Sand Canyon Plaza Mixed-Use Project Draft Final Environmental Impact Report

May 2017

Contents

Figure 3-16 Off-Site Mobility Plan

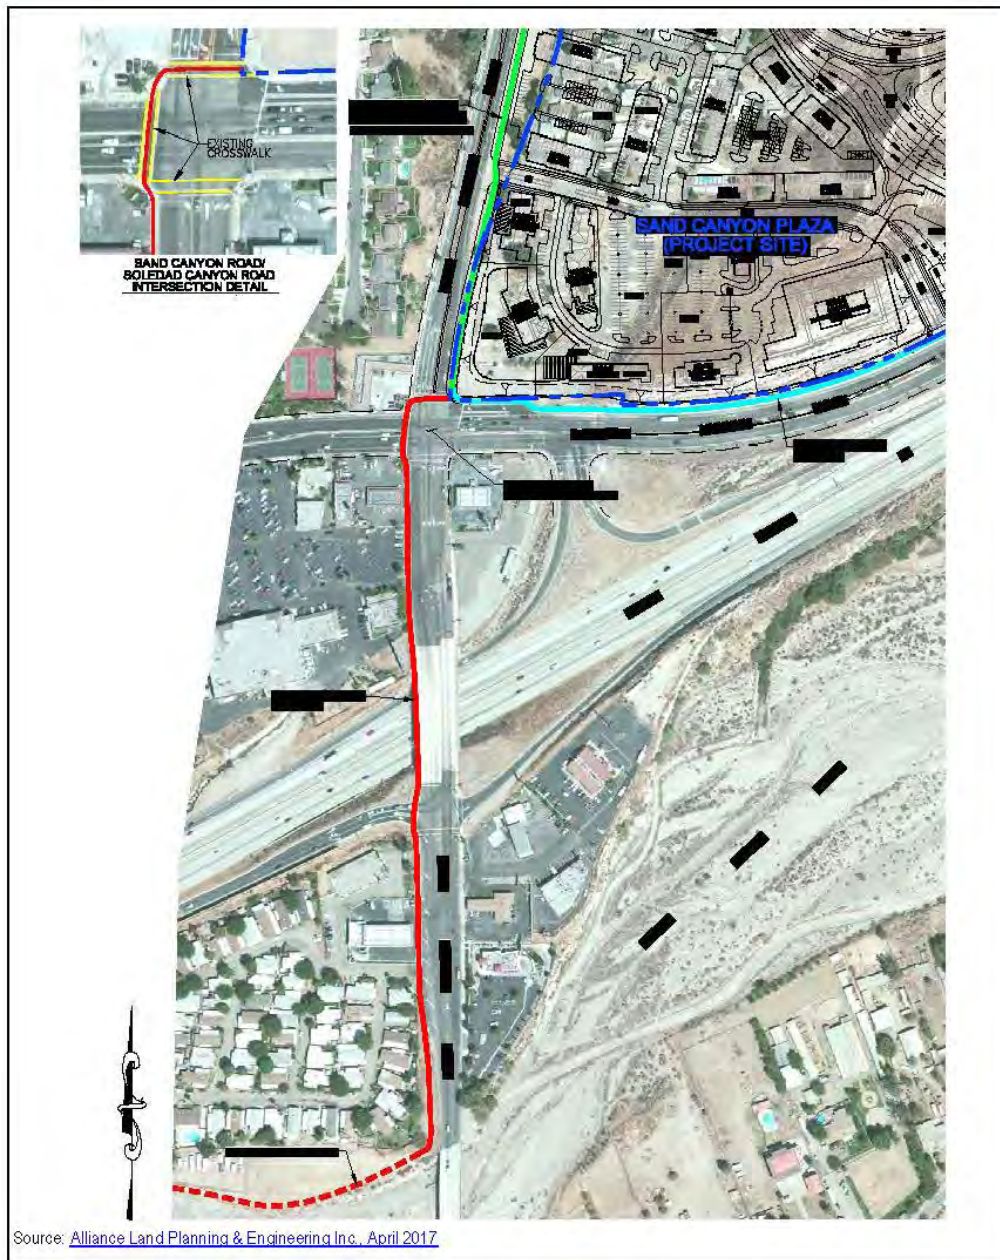
The Project provides for non-vehicular modes of transportation in a system of trails, sidewalks and pedestrian pathways commonly known as the Mobility Plan). The Mobility Plan achieves Project objectives by creating and enhancing opportunities for non-vehicular travel through encouraging pedestrian mobility from the Project's residential areas to the commercial uses. The Mobility Plan can be found in [Figure 4.19-3, Existing and Future Bicycle Facilities](#) (page [4.19-13](#)), and [Figure 4.14-2, City of Santa Clarita Trail System](#) (page [4.14-10](#)). [Off-site access to surrounding uses and the future Vista Canyon Metrolink Station are shown on Figure 3-16, Off-Site Mobility Plan, and Figure 3-17, Off-Site Mobility Plan to Metrolink.](#)

Figure 3.16 Off-Site Mobility Plan

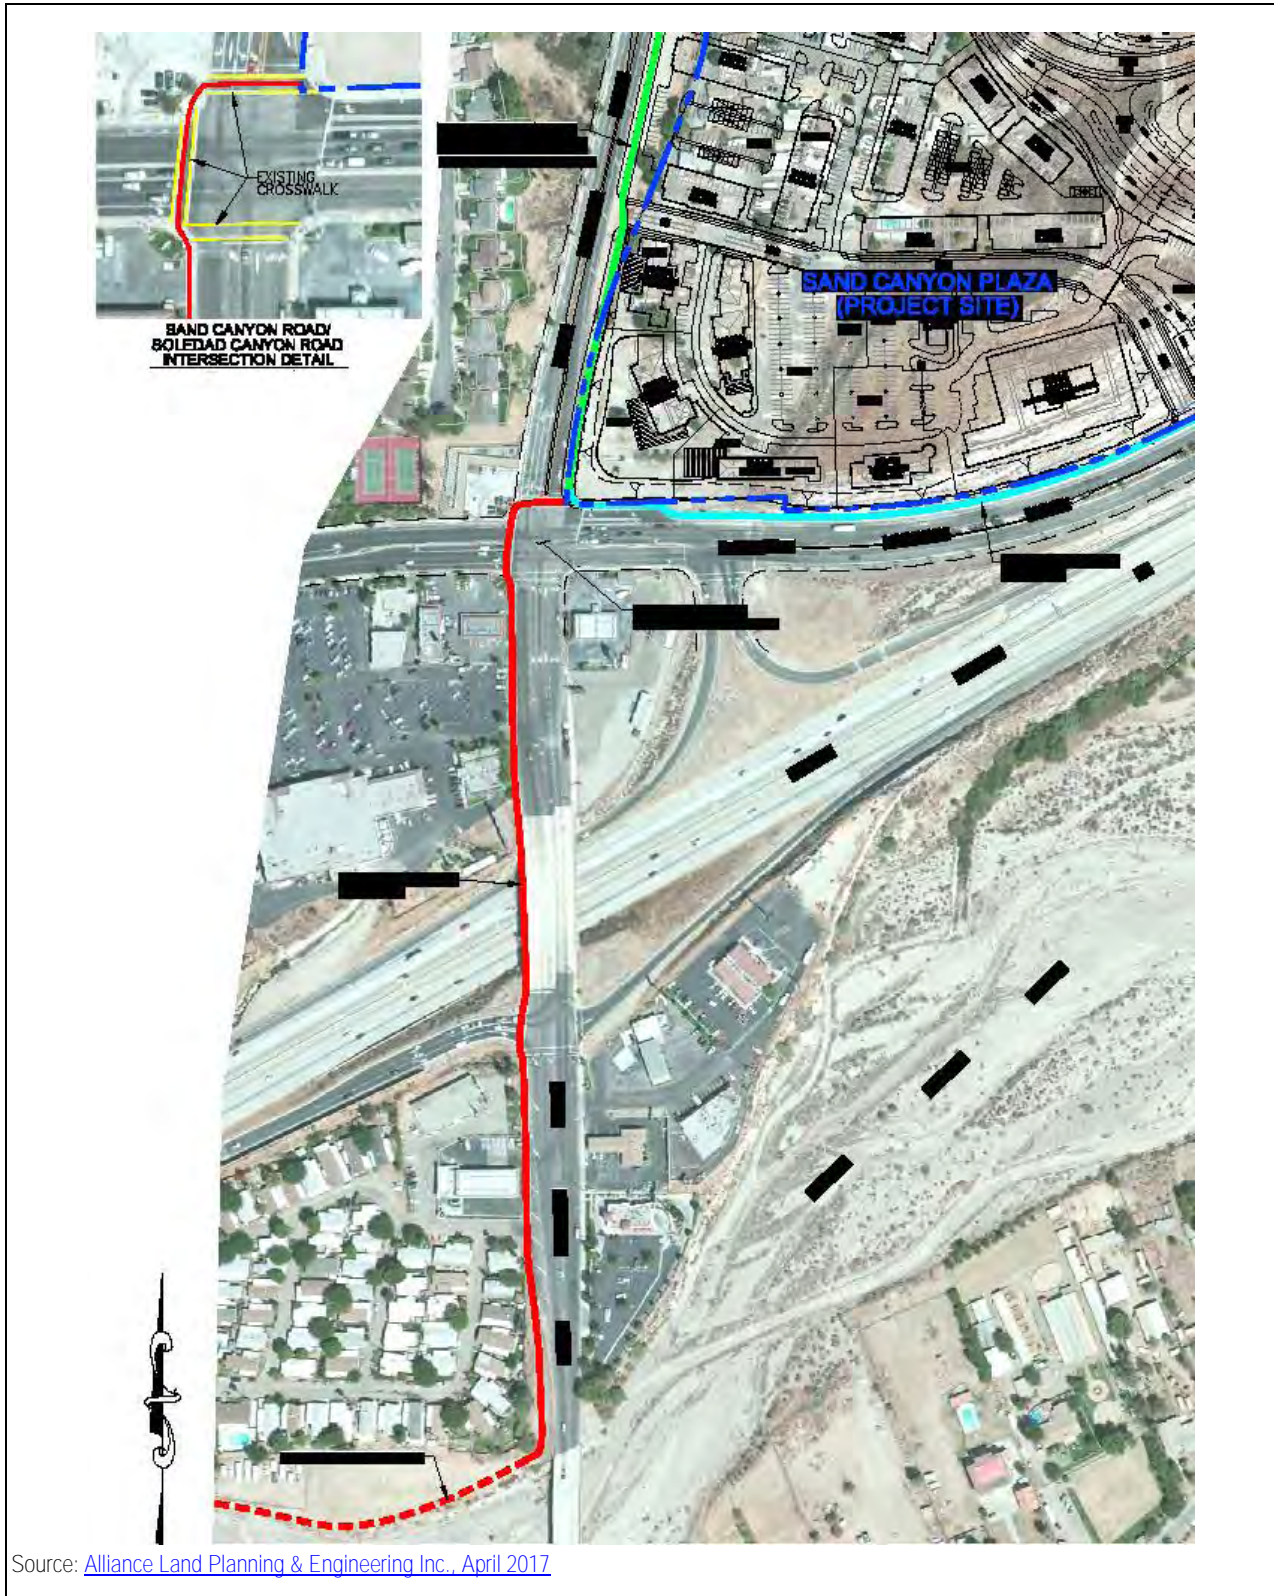
The Project provides for non-vehicular modes of transportation in a system of trails, sidewalks and pedestrian pathways commonly known as the Mobility Plan). The Mobility Plan achieves Project objectives by creating and enhancing opportunities for non-vehicular travel through encouraging pedestrian mobility from the Project's residential areas to the commercial uses. The Mobility Plan can be found in Error! Reference source not found., Error! Reference source not found. (page [Error! Bookmark not defined.](#)), and Error! Reference source not found., Error! Reference source not found. (page [Error! Bookmark not defined.](#)). [Off-site access to surrounding uses and the future Vista Canyon Metrolink Station are shown on 0, Figure 3.16 Off-Site Mobility Plan, and 0, Figure 3.17 Off-Site Mobility Plan to Metrolink.](#)
